Village of Arlington Heights  
Plat and Subdivision Committee  
Community Room, 3rd Floor  
Arlington Heights Village Hall  
33 S. Arlington Heights Road  
Arlington Heights, IL 60005  
January 14, 2015  
6:30 PM

**Item:** Northwest Crossings - 1501 & 1421 W. Shure Dr.- T1470

## **STAFF DEVELOPMENT COMMITTEE REPORT**

**Item:** Wireless Antenna Tower - 1000 S. Arlington Heights Rd. - T1487

## ENLARGED SITE PLAN

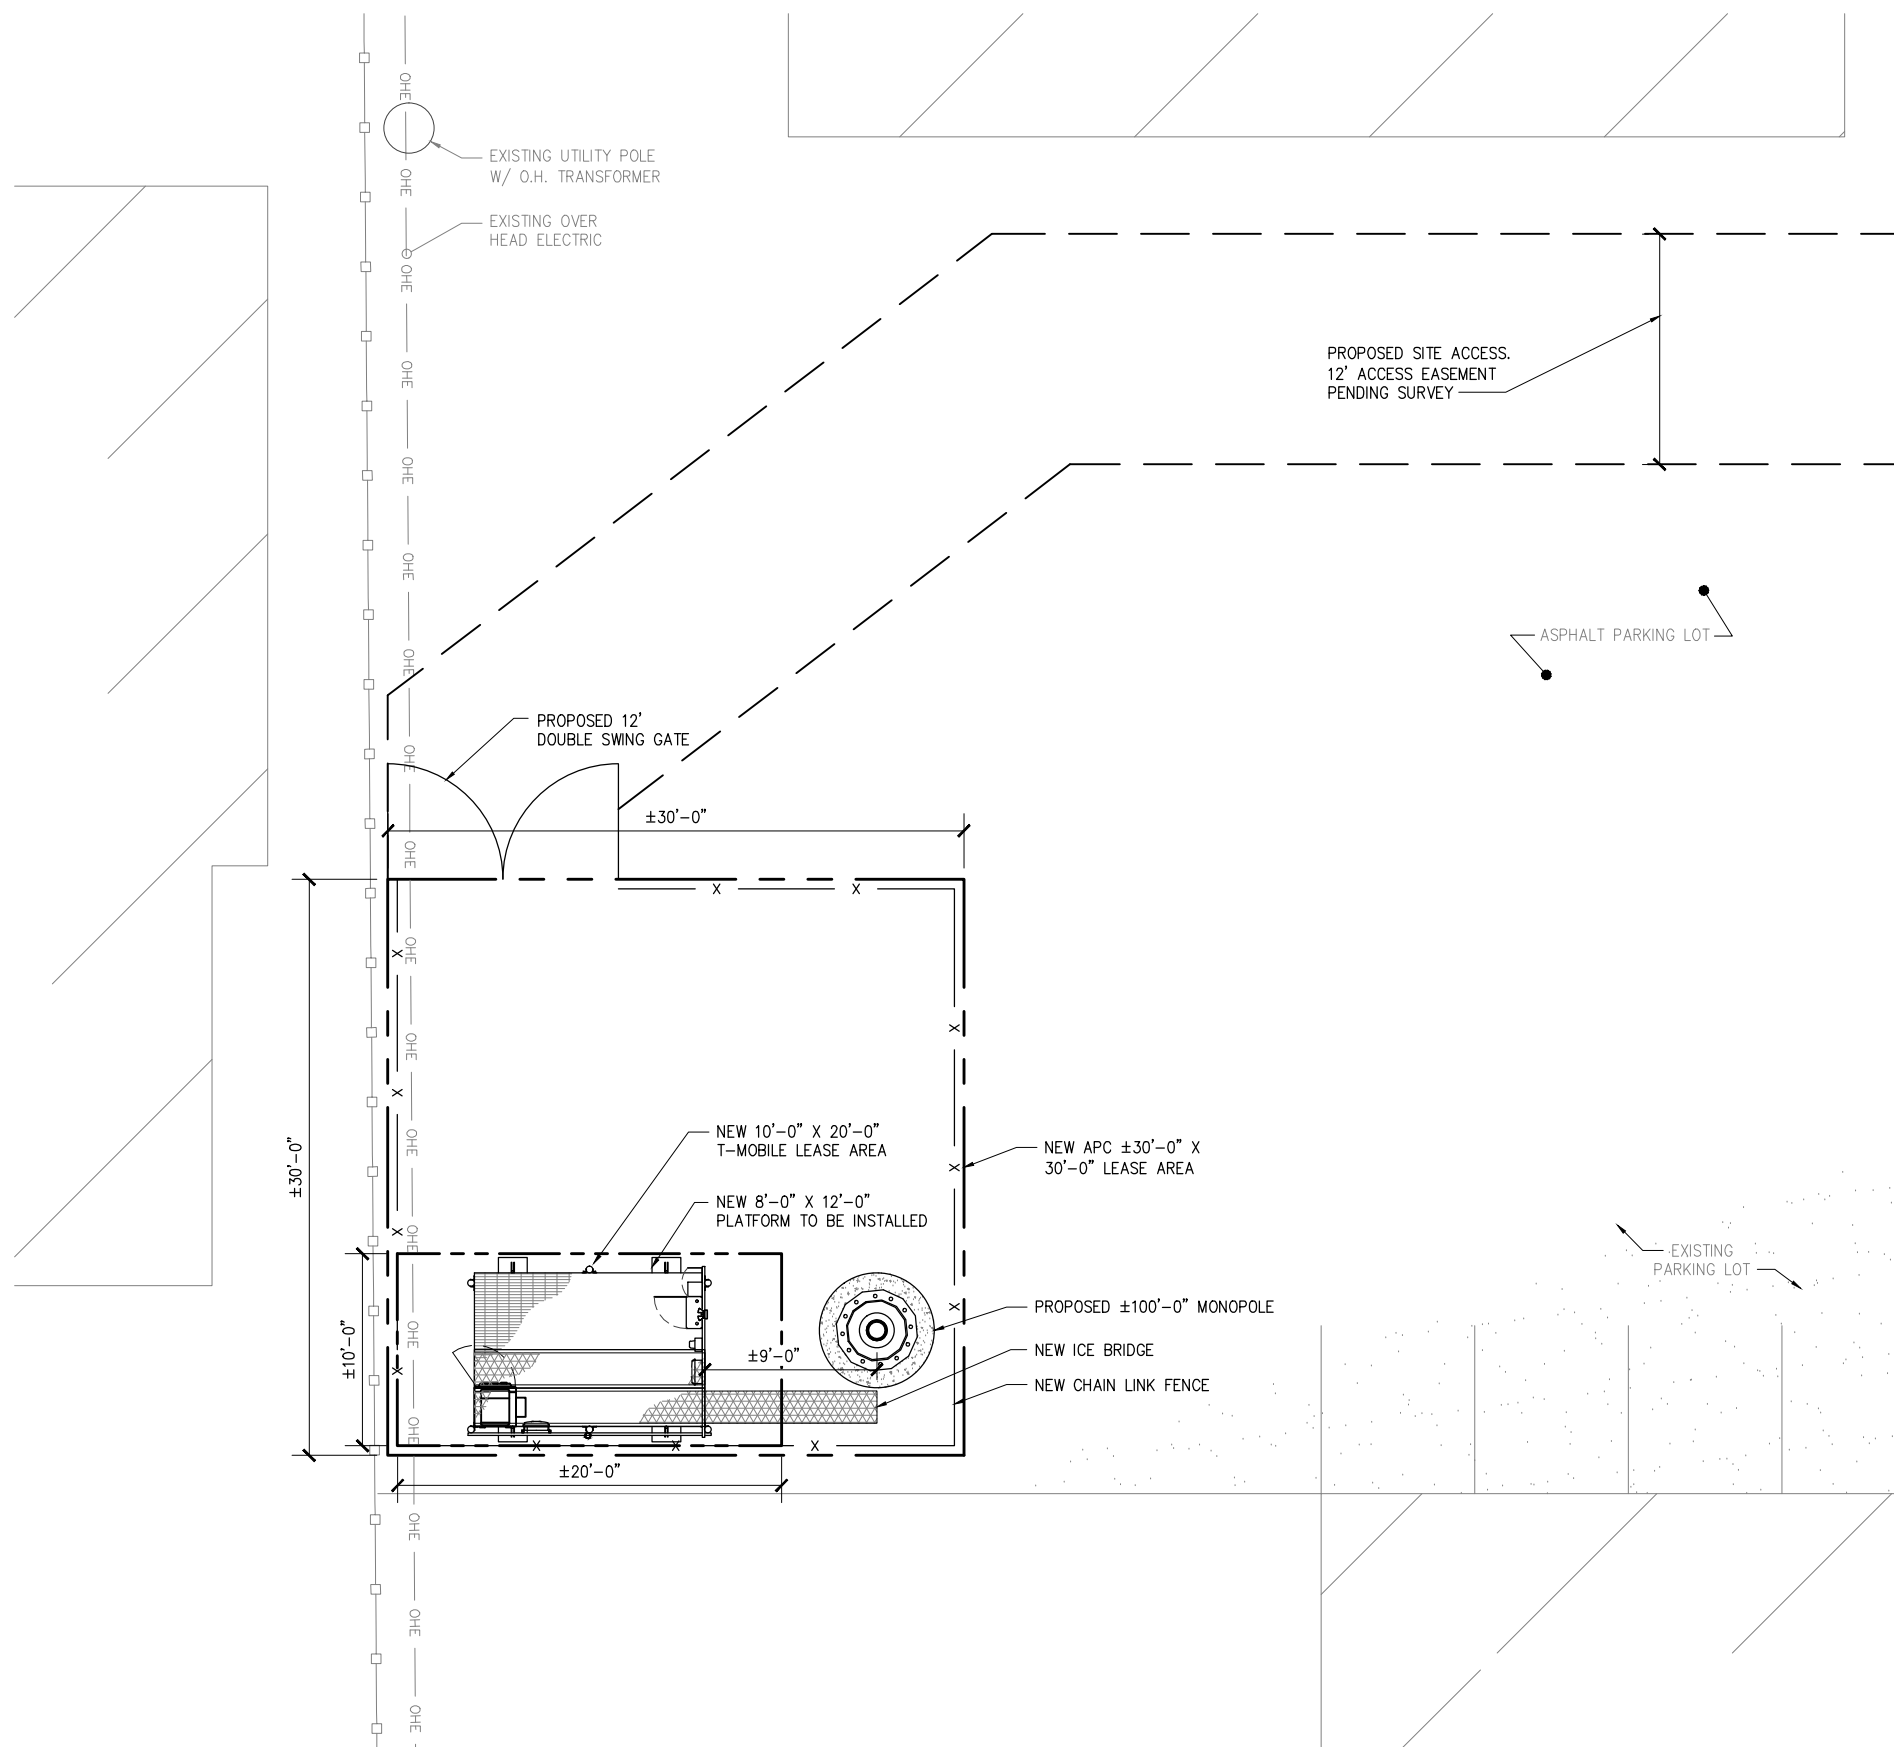
The proposed monopole will be located at the southwest corner of the property, visible from both Arlington Heights Road and Central Avenue. The applicant is proposing a chain link fence enclosing the four parking spaces where the base station and the monopole will be located. Per Chapter 28, Section 6.14-2.2, a landscaping plan is required to be submitted that demonstrates substantial screening of the antenna and related structures from adjacent land uses. Screening must consist of a well-maintained masonry wall of brickwork or stonework, solid wood fence, densely planted compact hedge or berm and hedge. It appears that adequate room is not available on the site to provide substantial landscape screening. The proposed chain link fence does not meet the screening requirements of Chapter 28. The applicant should work with staff to adequately address the screening requirement.

For the subject property, the side along Central Road is considered as front and the side along Arlington Heights Road is considered exterior side. For properties in the B-2 district, where a side (west property line) or rear (south property line) lot line coincides with a side or rear lot line of a property in an adjacent residential district, a yard equal in dimension to the minimum yard required for a residential use on the adjacent property in the residential district must be provided. Since the side and rear lot line of the subject property does not coincide with the side or rear lot line of the property in an adjacent residential district, therefore, the antenna structure must be located no closer than ten feet to any lot line. A variation is required to allow the antenna to be as close as 5 feet to the rear property line.

Four parking spaces will be removed to locate the antenna and the base station, reducing the total parking spaces on-site to 21 spaces. Per Chapter 28, Section 6.12-1, any special use less than 5,000 square feet in floor area and located along a major or secondary arterial street (Arlington Heights Road and Central Road) as defined by the Village's Thoroughfare Plan, does not need to provide a traffic study, but shall be required to provide a detailed parking analysis. The analysis should document the impact of the proposed antenna and access easement on parking and traffic circulation on-site. A full parking plan for the site must be provided.
